TALLAWONG STATION **PRECINCT SOUTH**

ADDENDUM URBAN DESIGN REPORT

Rev. E_10.12.2020

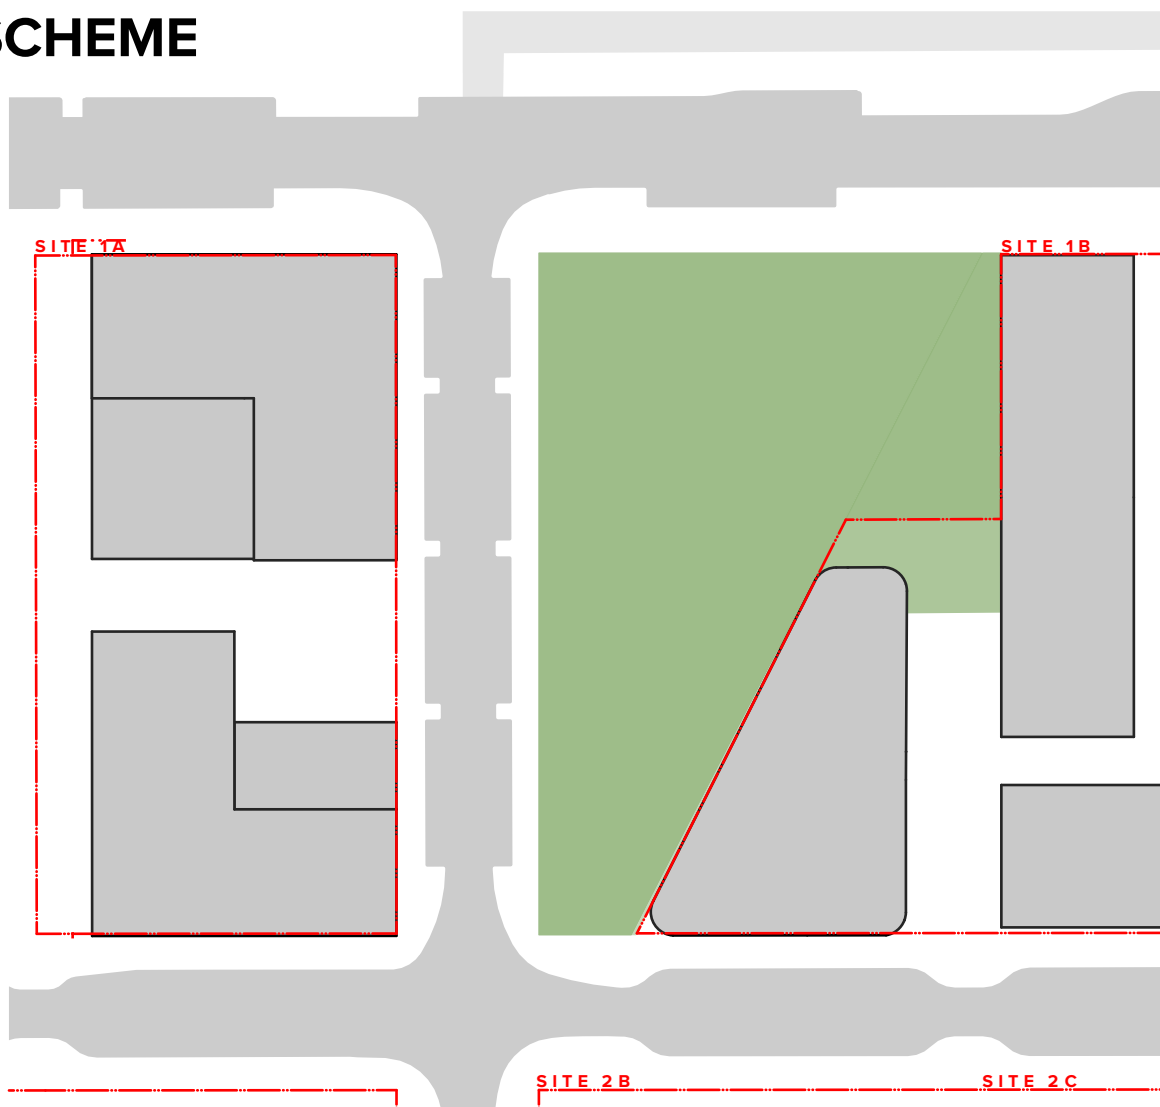
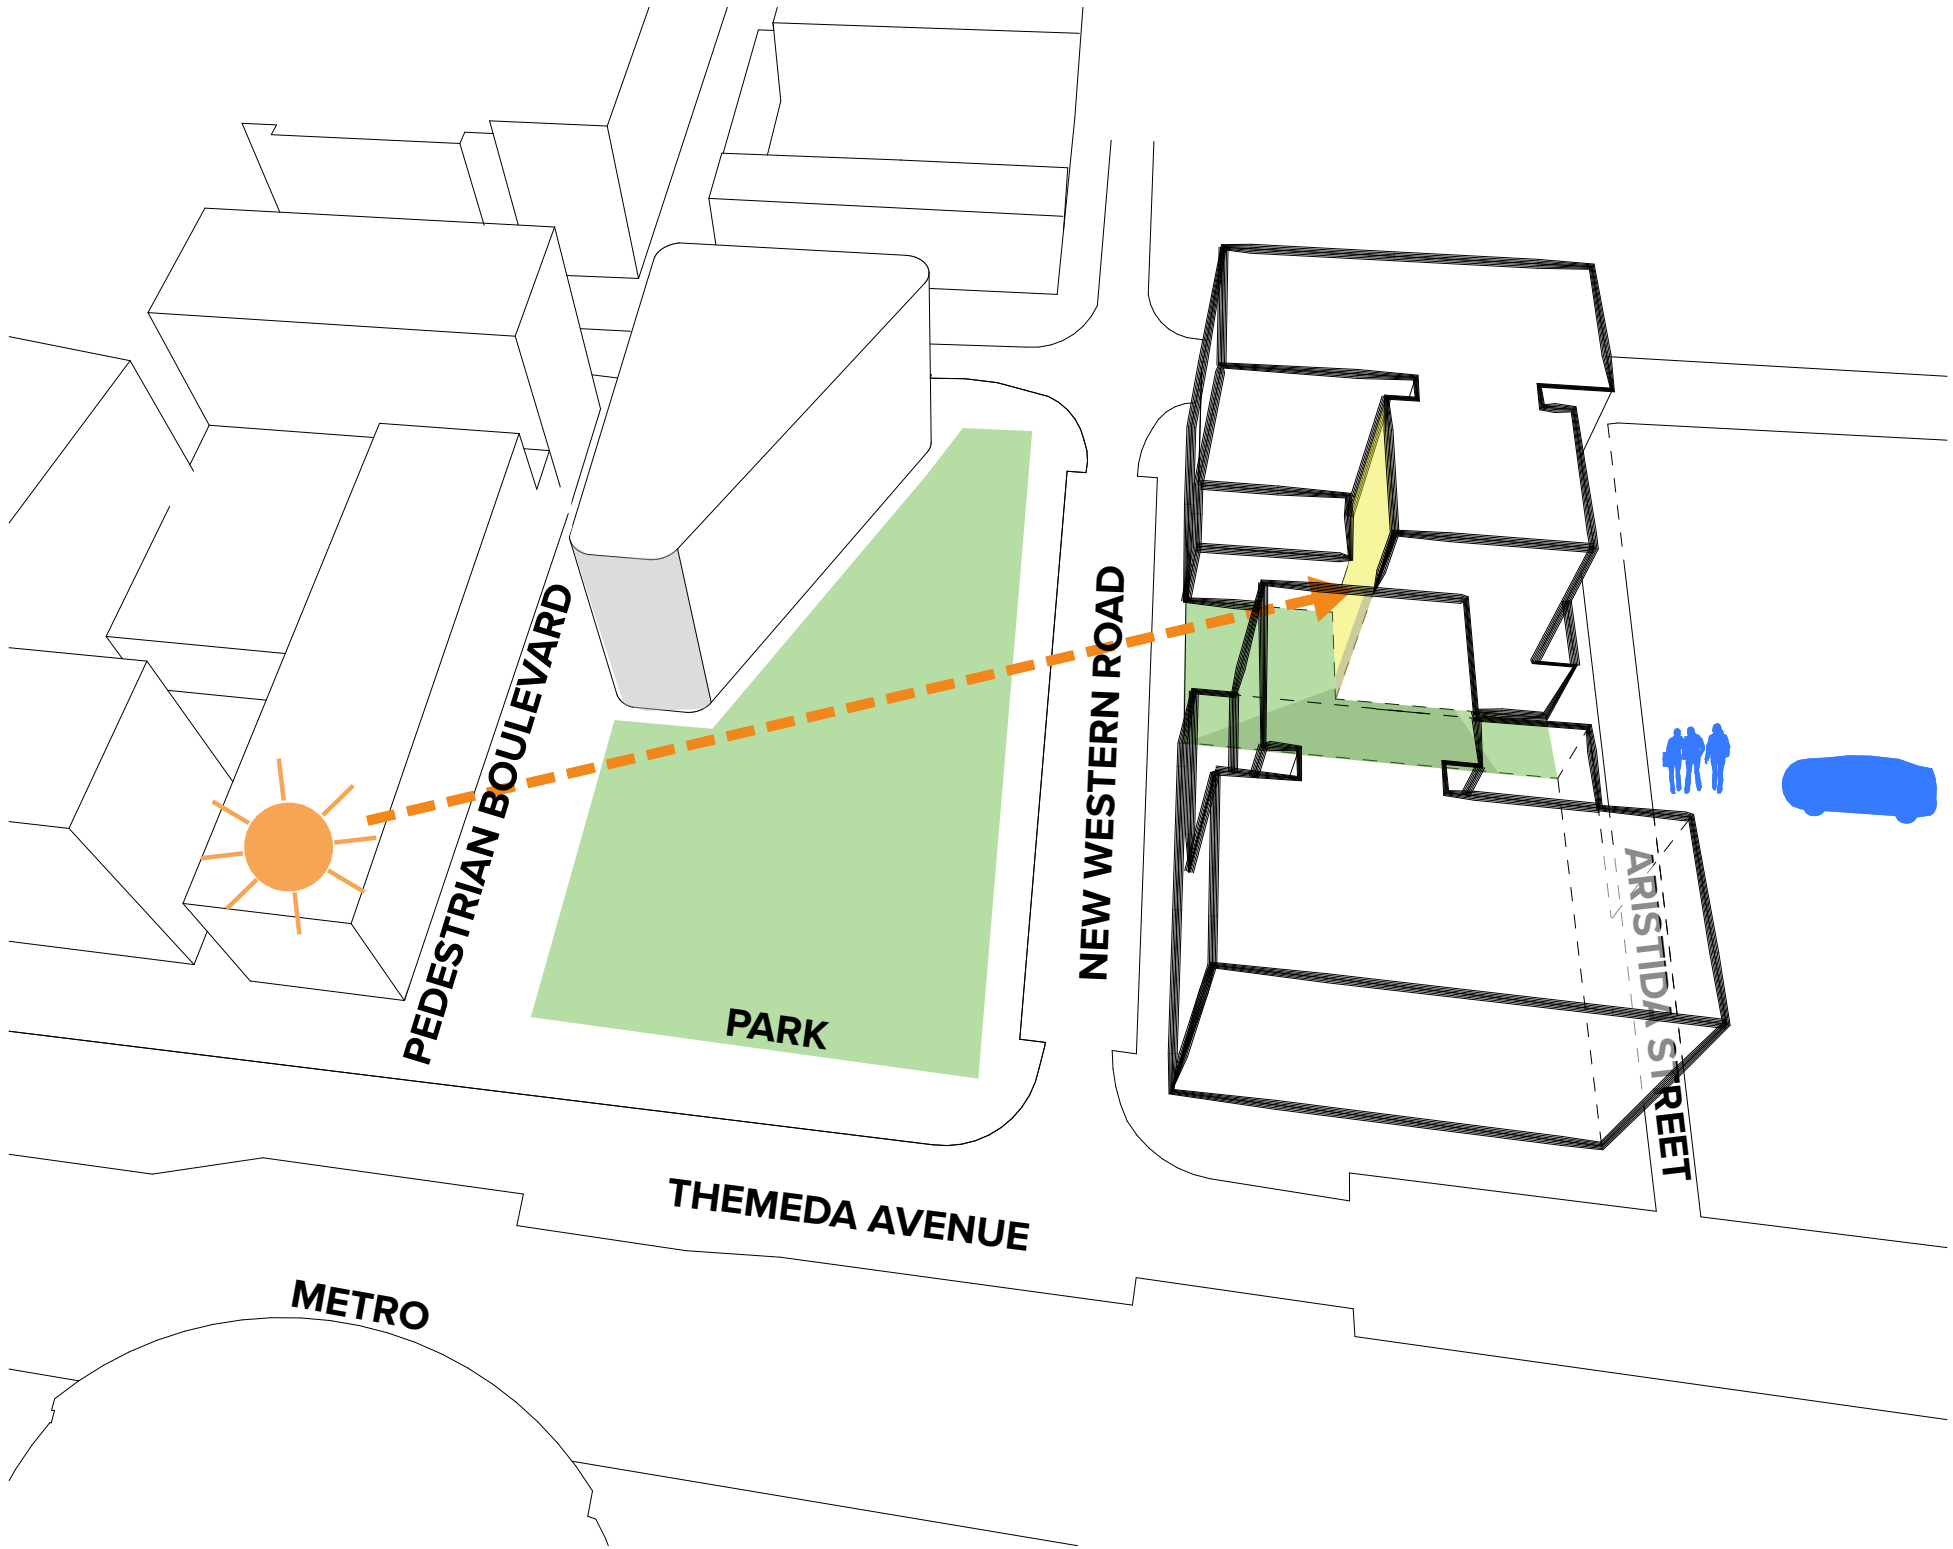
- ✓ Locally shift the built form to maximise solar access to the plaza and building facade
- ✓ Step the built form down to the park and commuter carpark to create a retail podium and provide opportunities for extended outdoor areas above
